RE: West Side Connection, Grading and Drainage Contract, Borough of Manhattan

This is in reply to your submission of three (3) copies of revised Drawing No. D-6 with a letter dated March 13, 1989 regarding the above referenced project.

WEST SIDE CONNECTION
GRADING & DRAINAGE

D-6

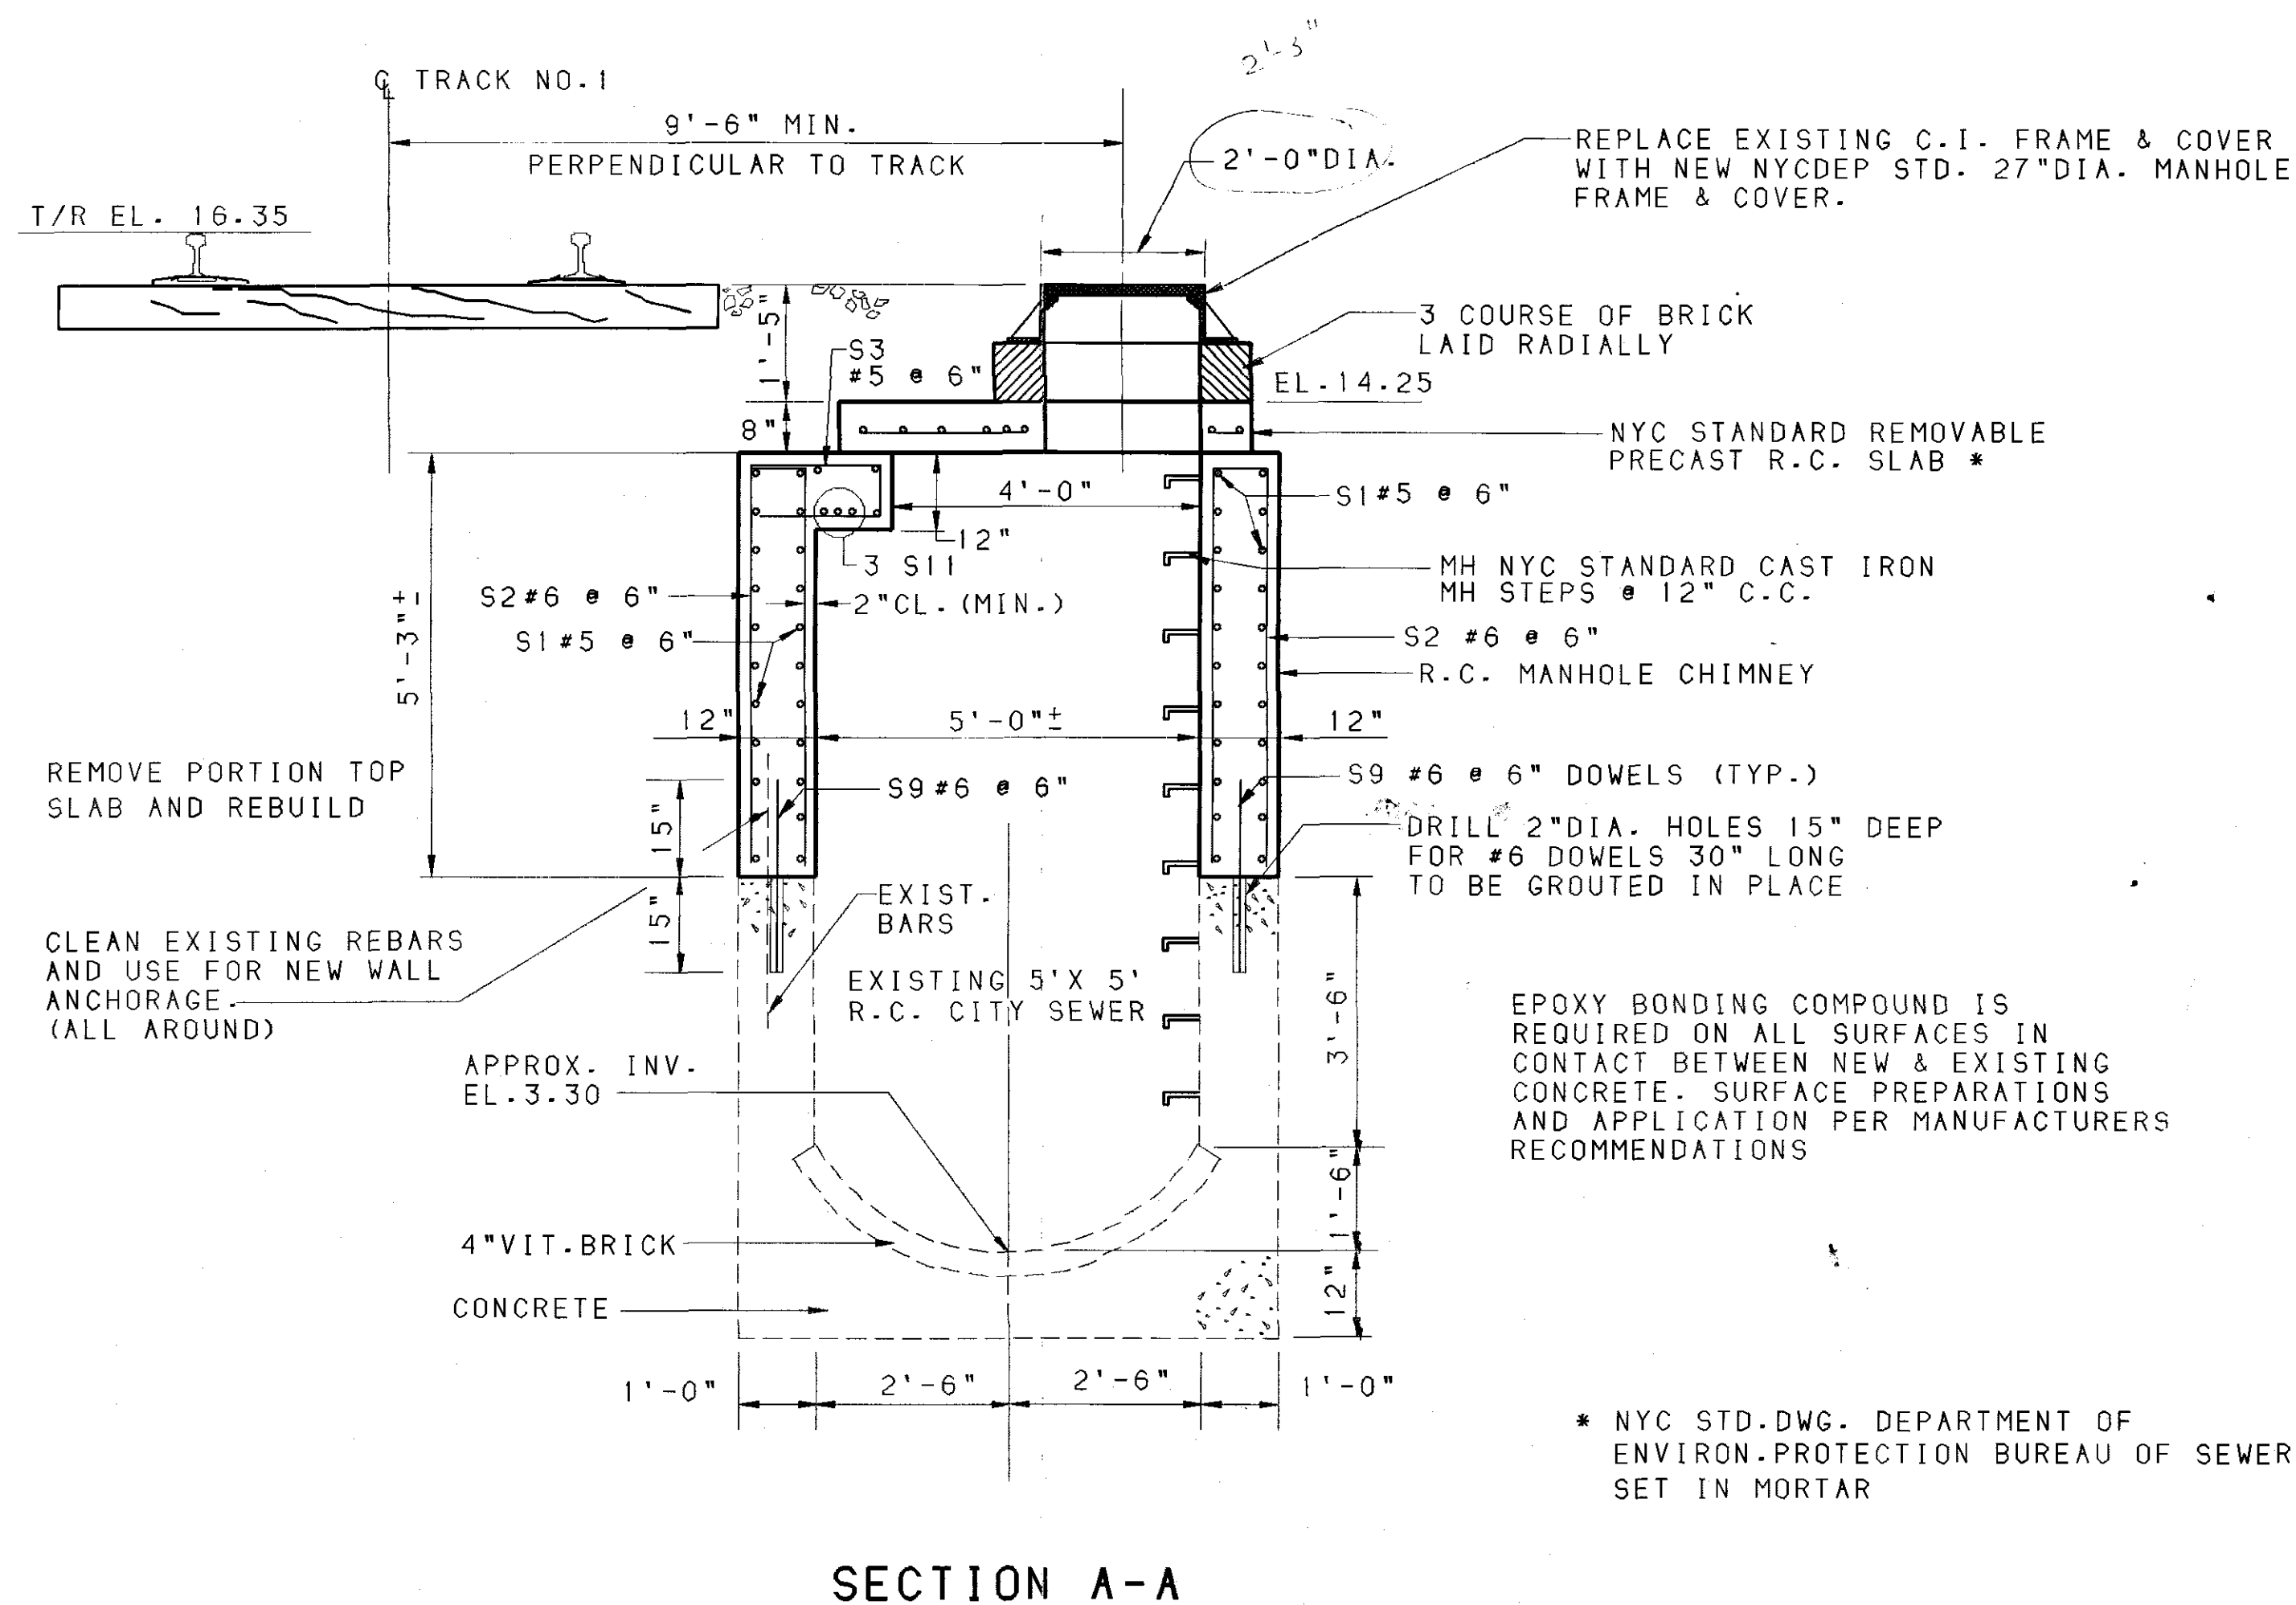
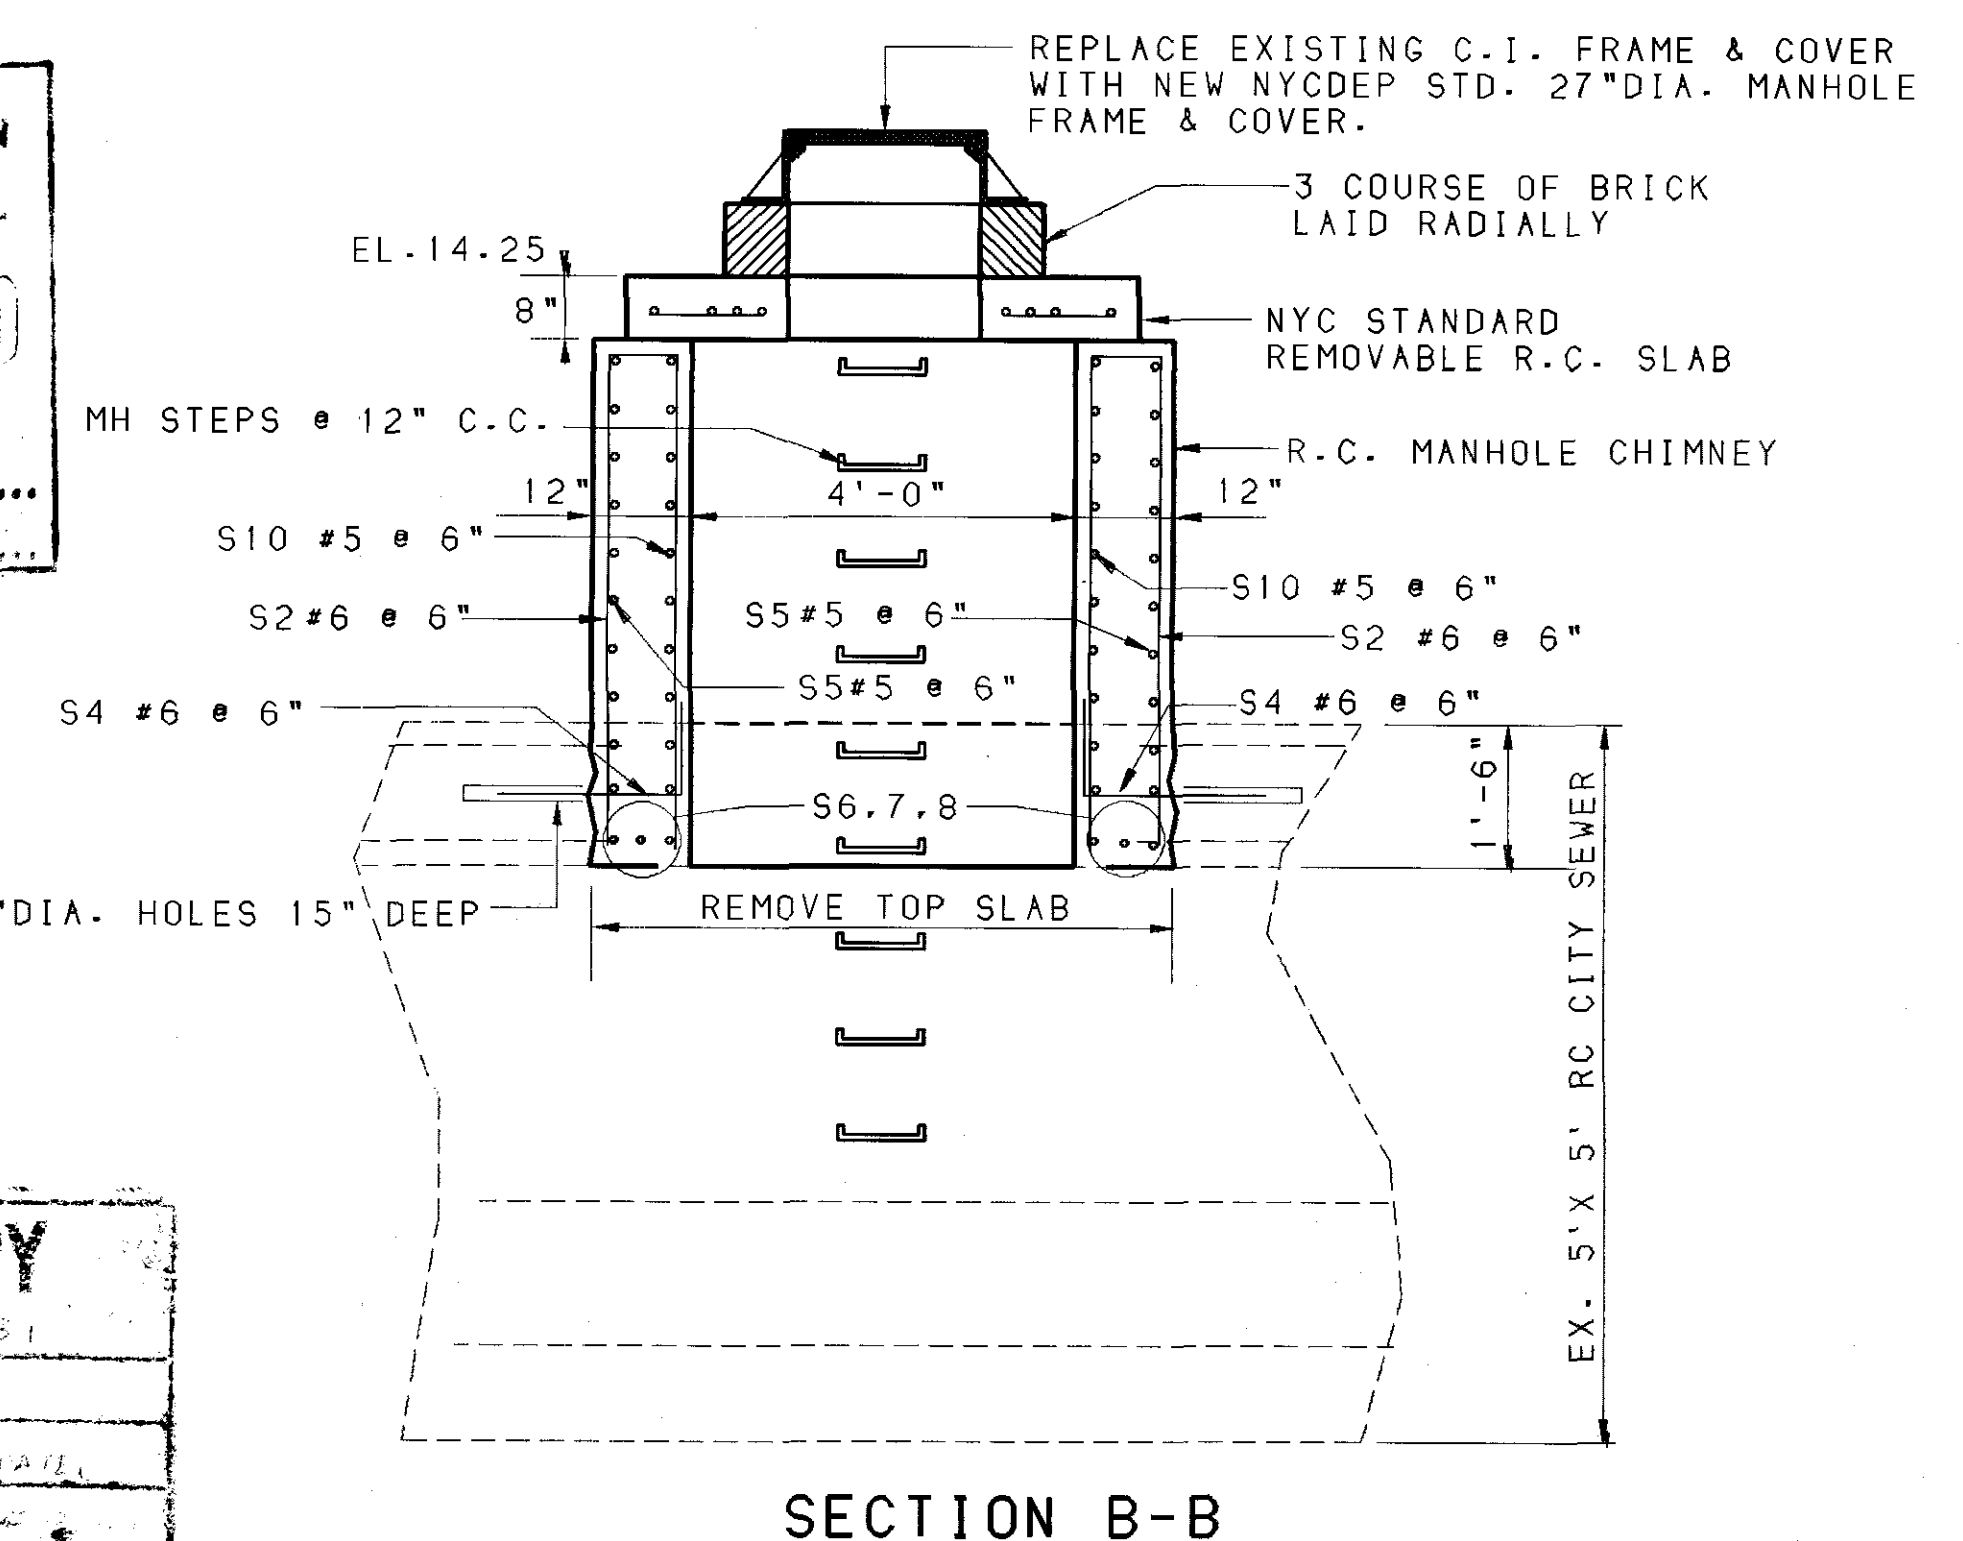
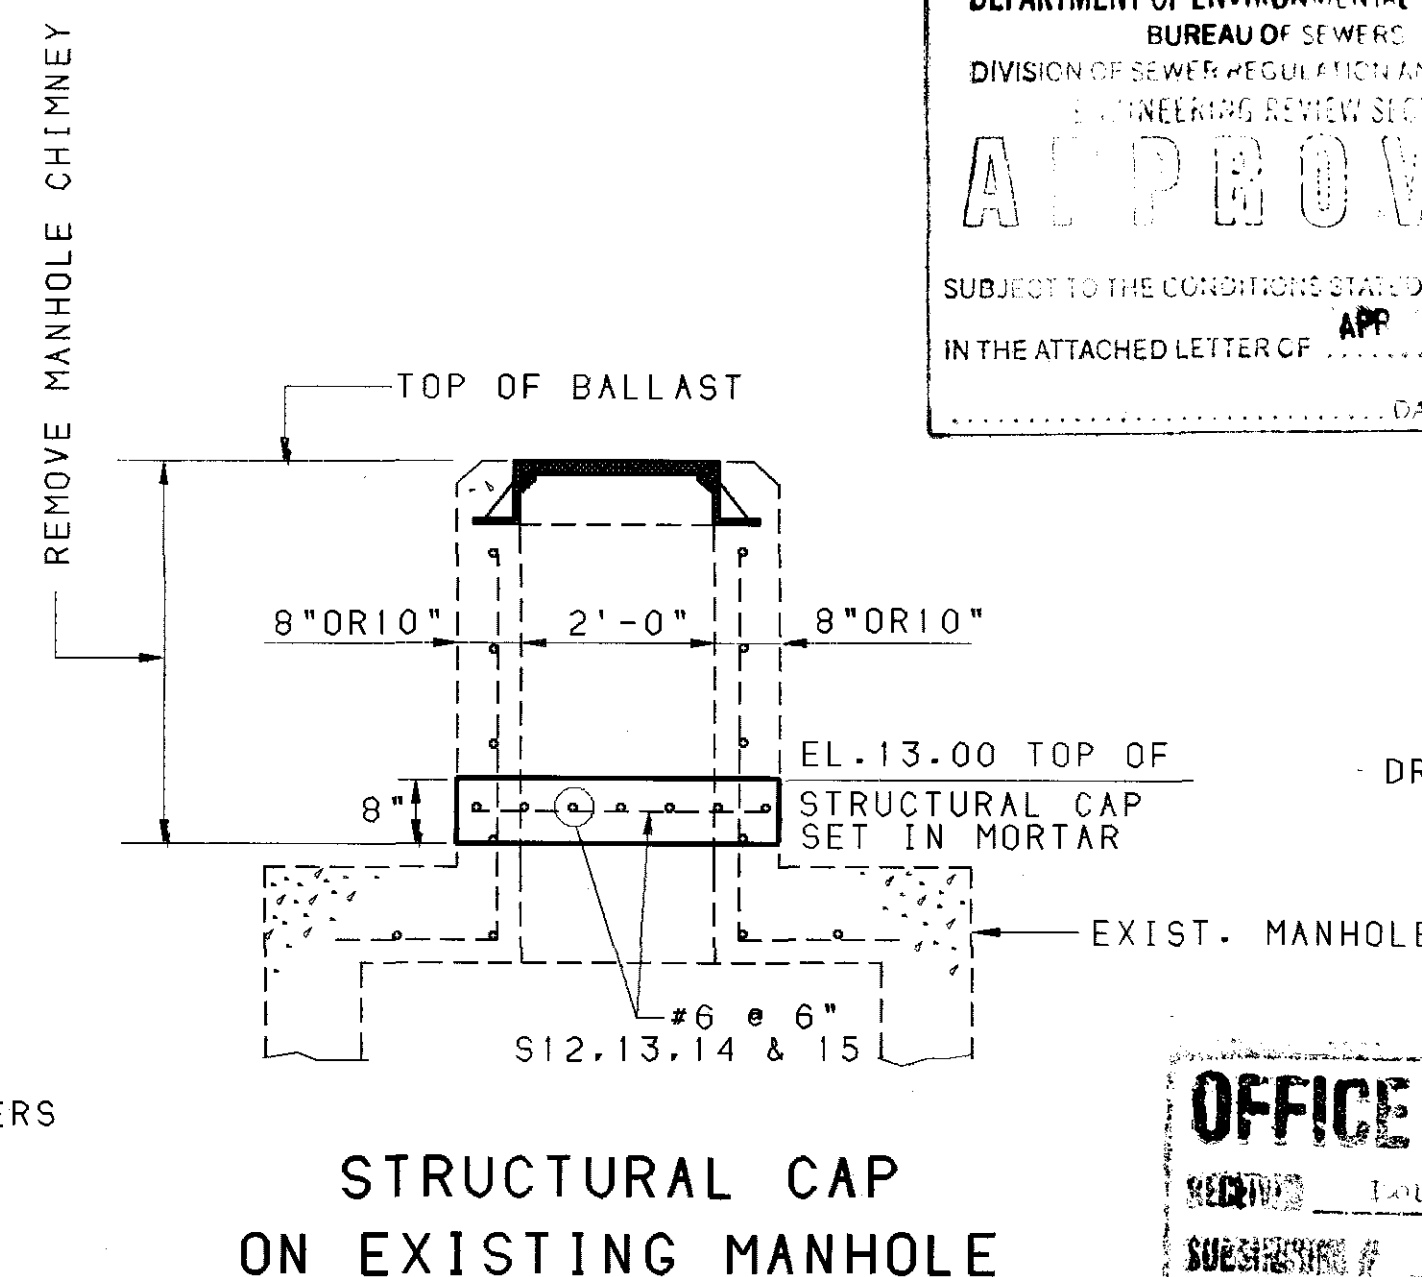
We have revised the design details for Manhole No.-14 in accordance with your markup copy of Drawing No. D-6.

Your submitted drawing has been reviewed by this department and is hereby approved. A copy of the drawing stamped "Approved" is enclosed herewith for your records.
